UNITED STATES PATENT AND TRADEMARK OFFICE

APPLICATION NO.	FILING DATE	FIRST NAMED INVENTOR	ATTORNEY DOCKET NO.	CONFIRMATION NO.
10/042,567	11/20/2001	Roger C. Williams	BIWLOWF	6838
45498	7590	06/03/2005	EXAMINER	
RISTO A. RINNE, JR. COMPLETE PATENTING SERVICES 2173 EAST FRANCISCO BOULEVARD, SUITE E SAN RAFAEL, CA 94901			HARVEY, JAMES R	
			ART UNIT	PAPER NUMBER
			2833

Office Action Summary

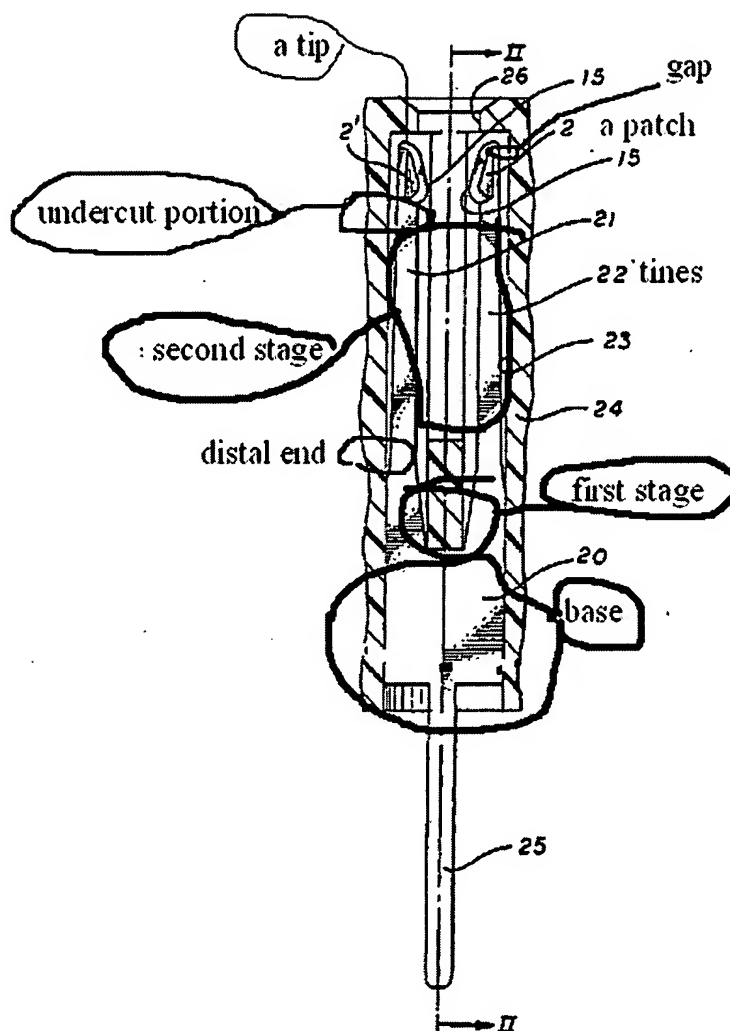
-- In reference to Claim(s) 3, Frommer shows (see examiner's figure) providing at each of the plurality of tines 22 first stage proximate a socket contact 24 having a first inner diameter disposed at one end thereof and which extends therefrom a distal end and where a second stage is

-- In reference to Claim(s) 5, Frommer shows (see examiner's figure) each of the tines 22 includes a first stage and a second stage, the first stage having a first wall thickness that is thicker than a second wall thickness of the second stage that is disposed proximate to the first stage and which extends therefrom toward a tip of each tine.

-- In reference to Claim(s) 6, Frommer shows an undercut portion (see examiner's figure) in each of the tines a predetermined distance from the tip.

-- In reference to Claim(s) 7, Frommer shows (see examiner's figure) the undercut portion extends to the first stage.

-- In reference to Claim(s) 8, Frommer shows (see examiner's figure) each of the tines includes a patch of material that is adapted to contact a pin, the patch being disposed intermediate the tip and the undercut portion.

-- In reference to Claim(s) 9, Frommer shows (see examiner's figure) the patch of material includes a greater thickness of material than the undercut portion.

-- In reference to Claim(s) 13, Frommer shows each of the plurality of tines 22 is machined wherein a tip (see examiner's figure) of each of the plurality of tines is normally disposed closer a center of the socket when the socket is not mated with a pin than second end (near the undercut portion detailed in the examiner's figure) of each the plurality of tines that disposed distally from the tip.

-- In reference to Claim(s) 14, Frommer shows (see examiner's figure) each of the plurality of tines have curved portions (at the patch shown in the examiner's figure)).
